ADDENDUM No. 5

Date: November 26, 2019
To: All Bidders
From: **Jenkins•Peer Architects**
Charlotte, N.C.
Re: UNC Charlotte – Residence Hall Phase XVI
SCO ID: 18-18333-02A
JPA Project #: 18NCC016

4 RACK ELEVATION - MDF 035
NO SCALE

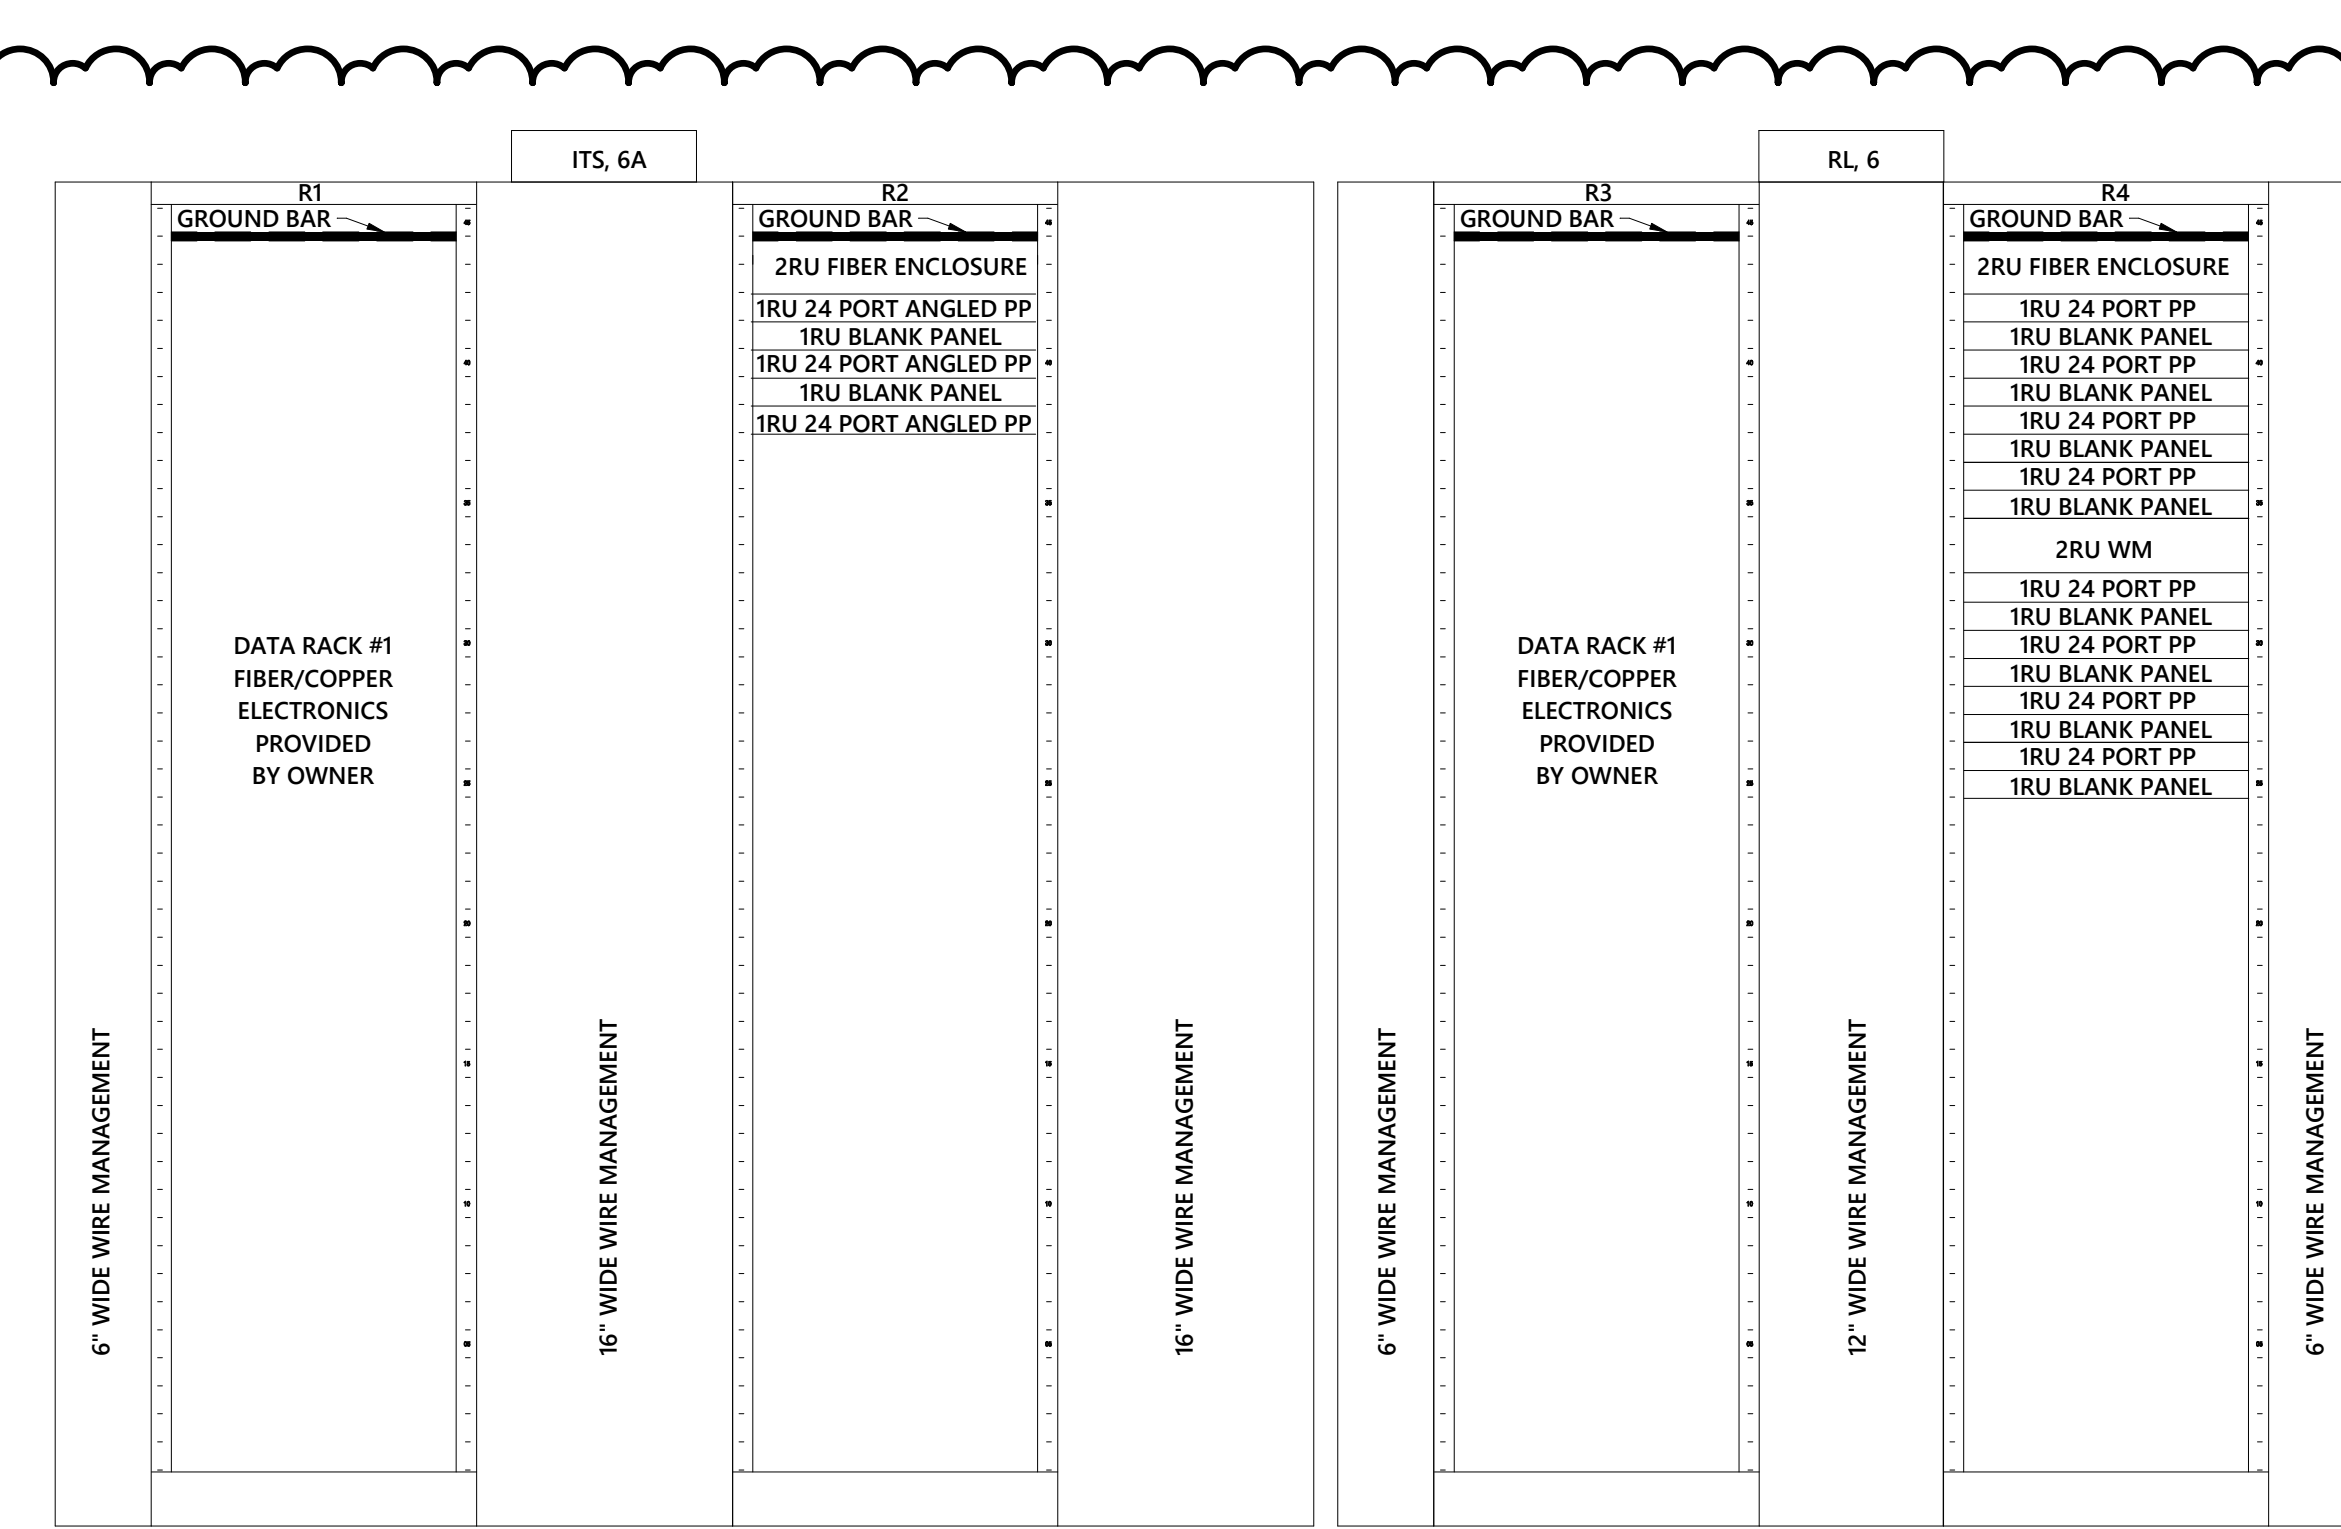
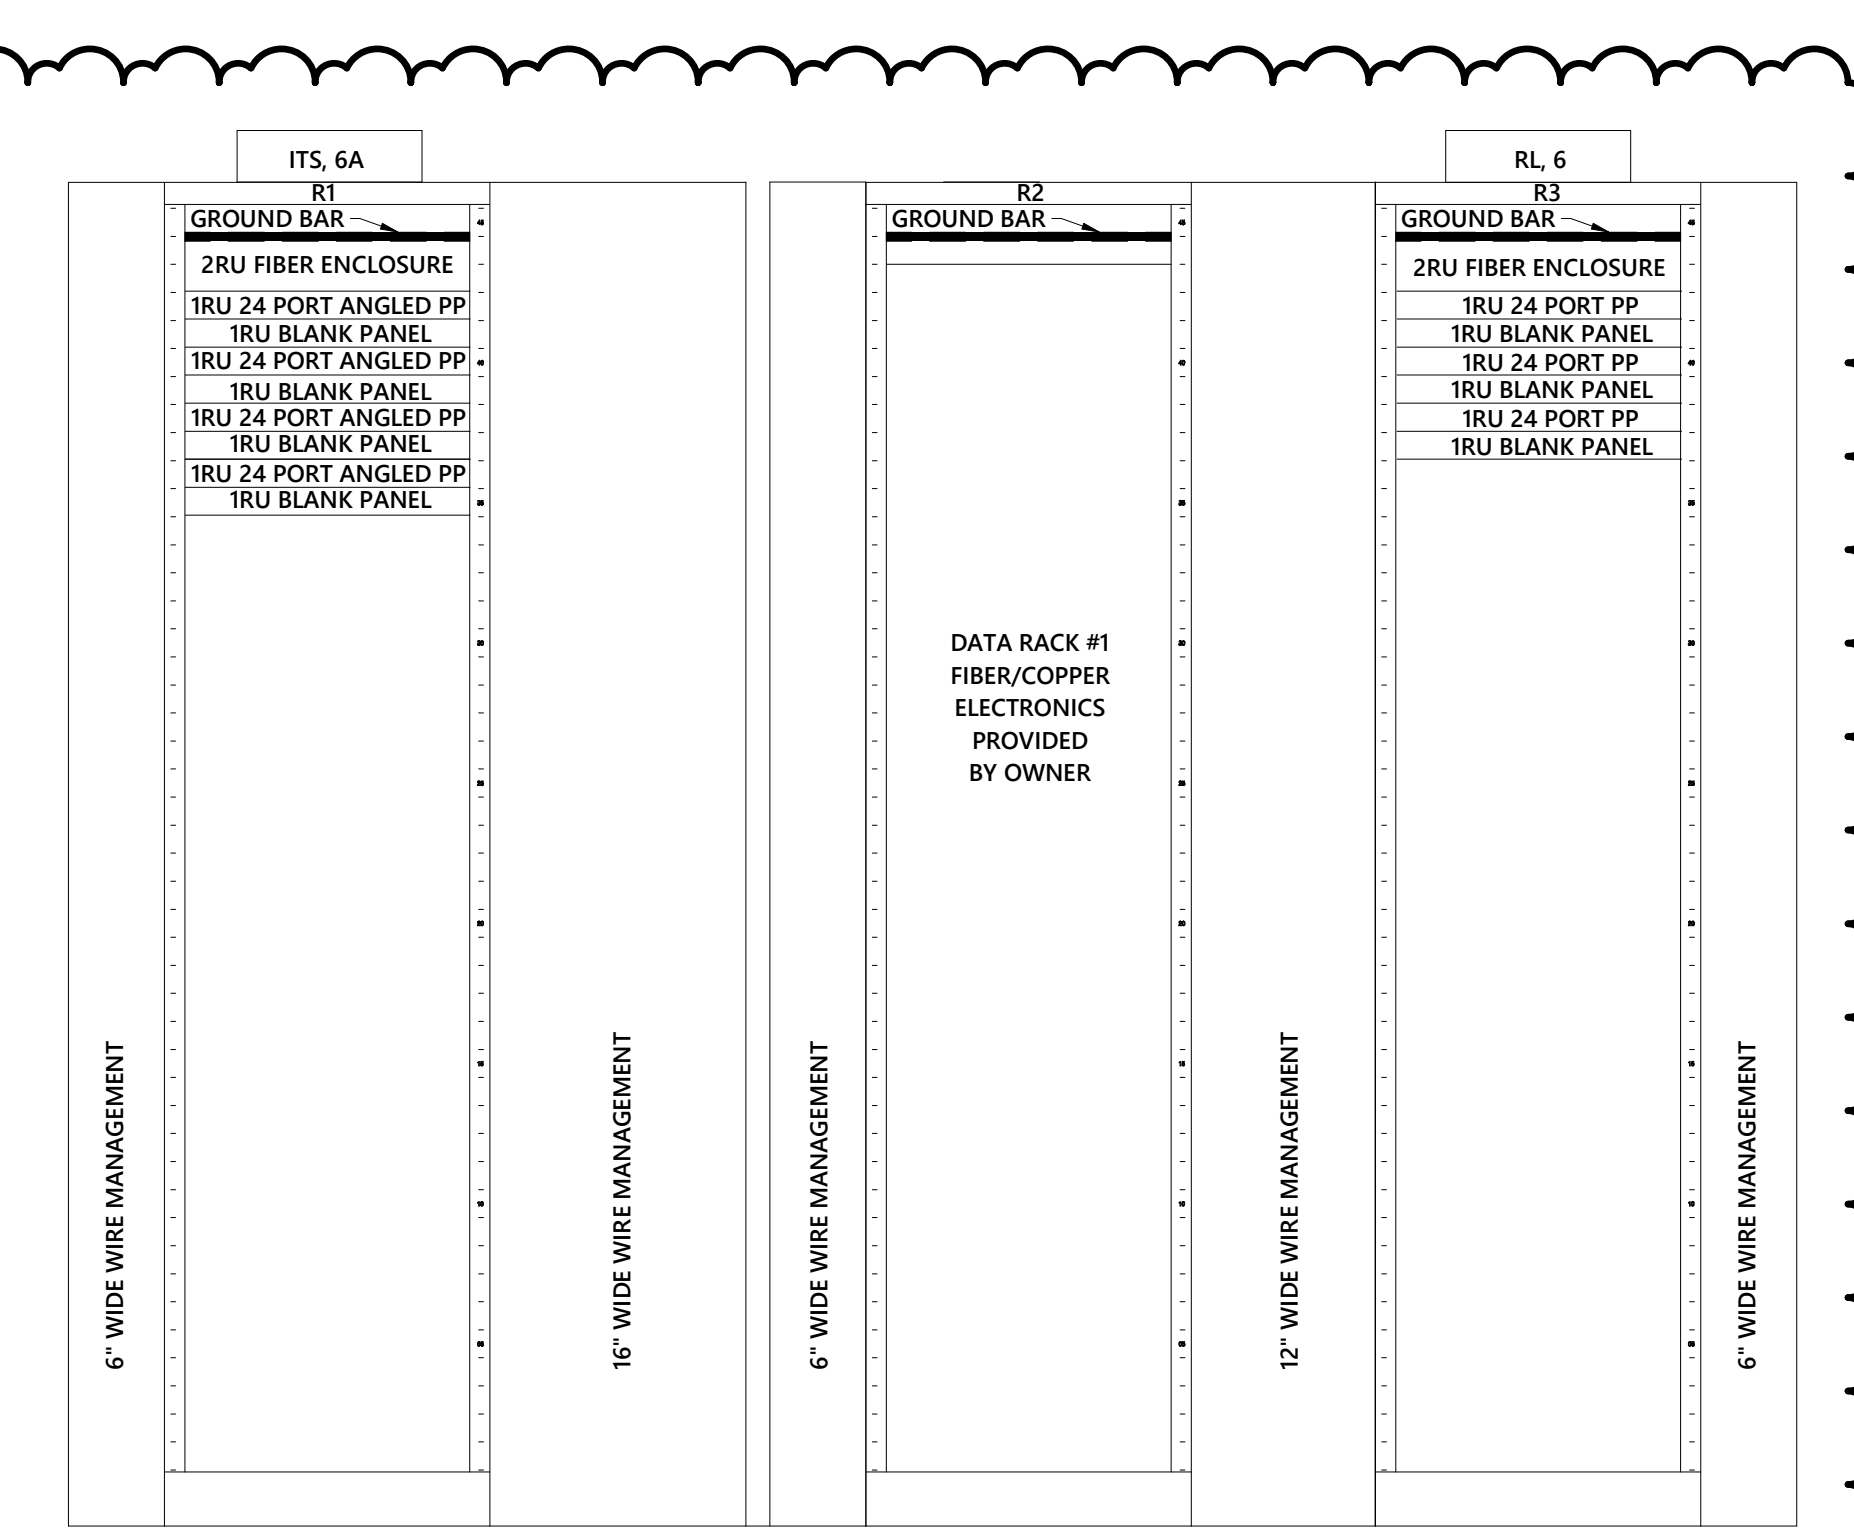
QUESTION: The legend (drawing TC-000) has two different types of WAP symbols. One type gets 2 CAT 6 cables. The second type with the subscript ITS gets 2 Cat 6A cables. The rack elevations only shows patch panels space for CAT6A WAP (yellow) cables. Do all WAPs get 2 CAT 6A cables or is there a mixture of CAT 6 and CAT 6A WAP outlets and the rack elevations need to have a CAT 6 panel for CAT 6 WAP cables?

QUESTION: Drawing TC-501 (rack elevations) does not show which rack the backbone fiber or the 25 pair copper should terminate in. Also what size fiber enclosure is required?

RESPONSE: There are two different types of WAPs with different cabling requirements. ITS cabling shall be terminated on ITS patch panel and Resident Life shall be terminated on RL patch panels in associated racks. Rack elevations will be updated for clarity.

RESPONSE: Terminate fiber optic cable in RL rack and 25 pair copper on patch panel in IDFs. Provide a 2RU enclosure for fiber connectivity. Rack elevations will be updated for clarity.
